## Development Review Division

**DATE:** Feb. 26, 2021

**SUBJECT:** SP20-131 Site Plan – Planning Review 1

**LOT 6 PARKER AND PINE FILING 1**  
 PARKER, CO  
 EVERBROOK ACADEMY SITE PLAN  
 SITE PLAN

**1 PHOTOMETRIC PLAN**  
01 of XX SCALE: 1/16" = 1'-0"

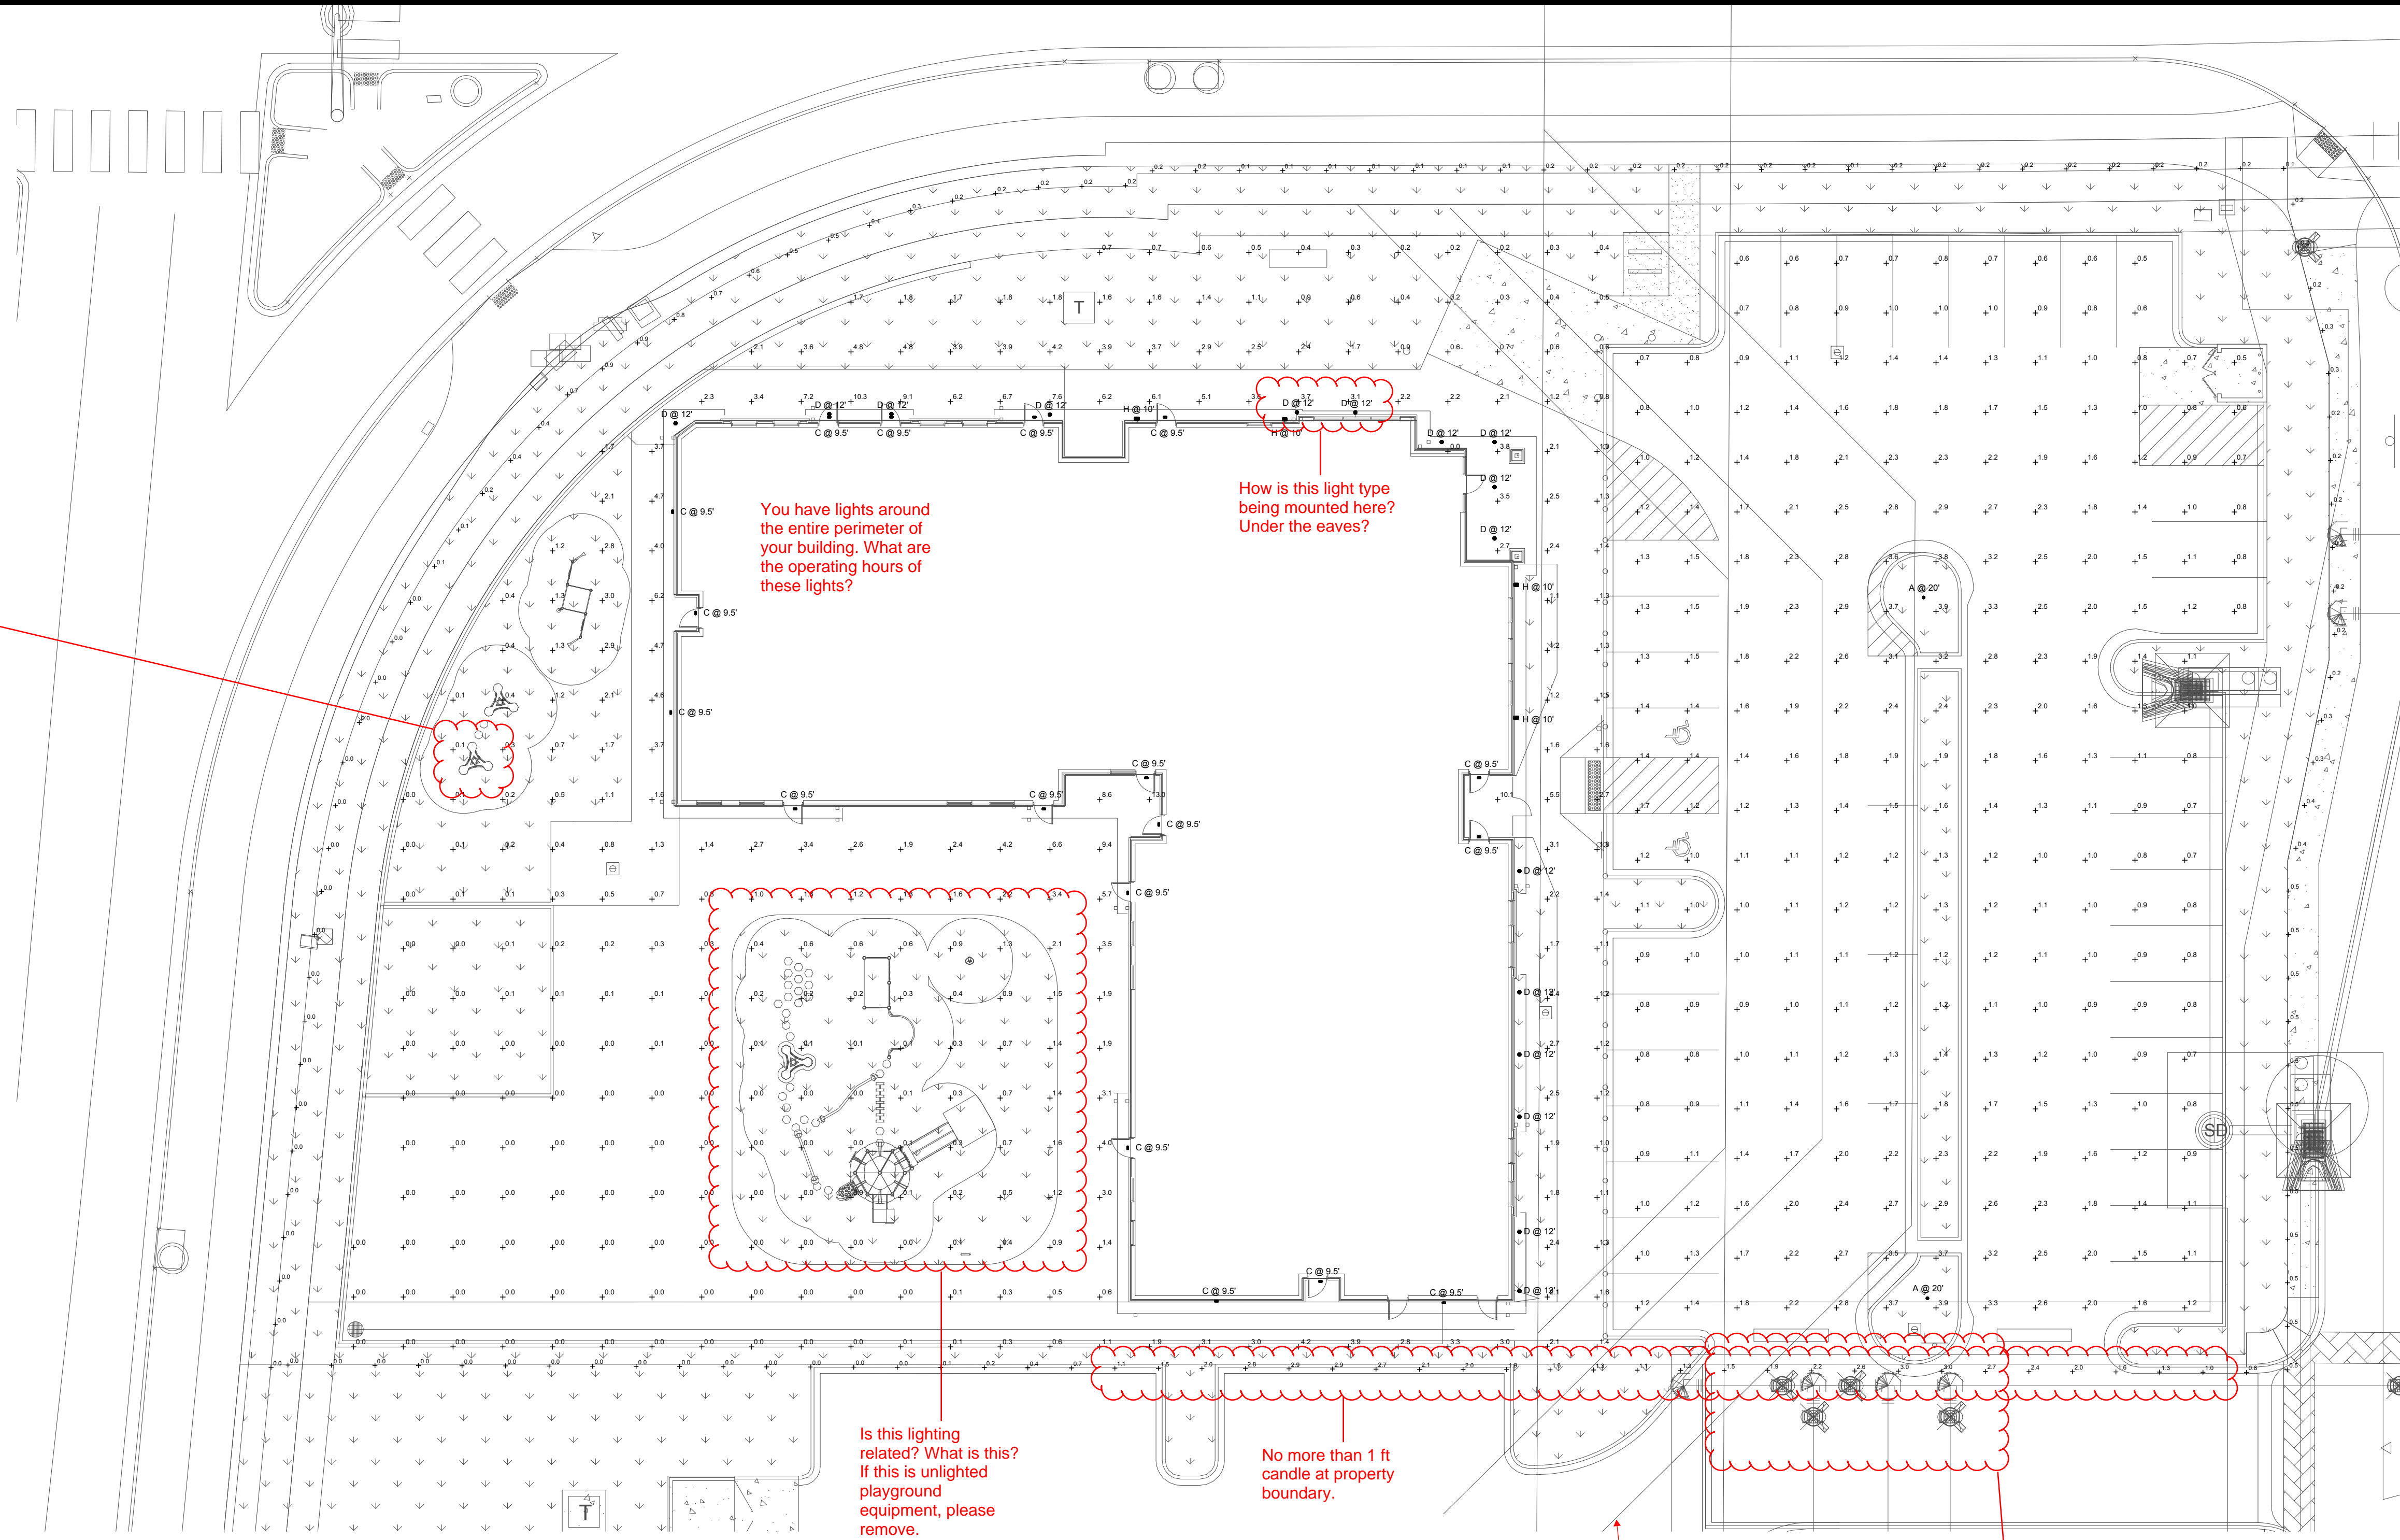
Label property line

Shape not in legend. What are these?

Use symbols with fill. It is unclear what is going where now. Did you insert the polar plot on top of the symbols?

Use the symbol on the plan, not just the letter. Hard to see them amidst the photometric numbers.

You have lights around the entire perimeter of your building. What are the operating hours of these lights?

How is this light type being mounted here? Under the eaves?

Is this lighting related? What is this? If this is unlighted playground equipment, please remove.

No more than 1 ft candle at property boundary.

What are these lines signifying here?

What are these?

Our maximum is 12 foot candles anywhere on site. Please circle on plan where this is.

Add mounting height to table.
